**Addendum to Long Term Water
Supply to Clearview, Schedule B
Class EA**

**Community of Stayner
Township of Clearview**

Appendix D

EA Addendum Consultation

Figure 1: Map of project location including layers for HVA and SGRA.

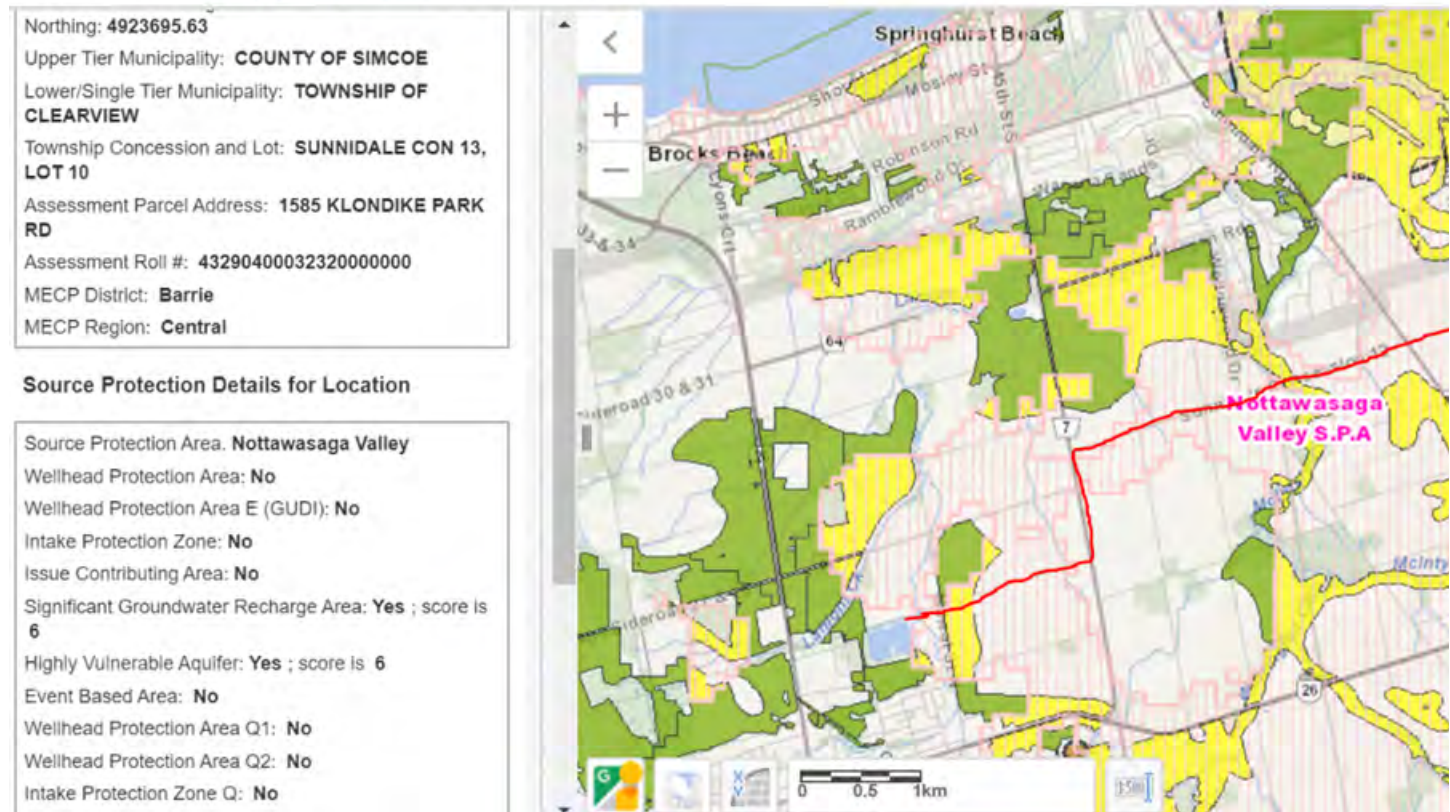
The proposed establishment of 3 new wells, an on-site pumphouse including backup generator, and several kilometers of connecting watermain is planned to occur in the area north east of the community of Stayner. There are no existing WHPAs or IPZs, however project work will occur within HVAAs and SGRAs (see Figure 1).
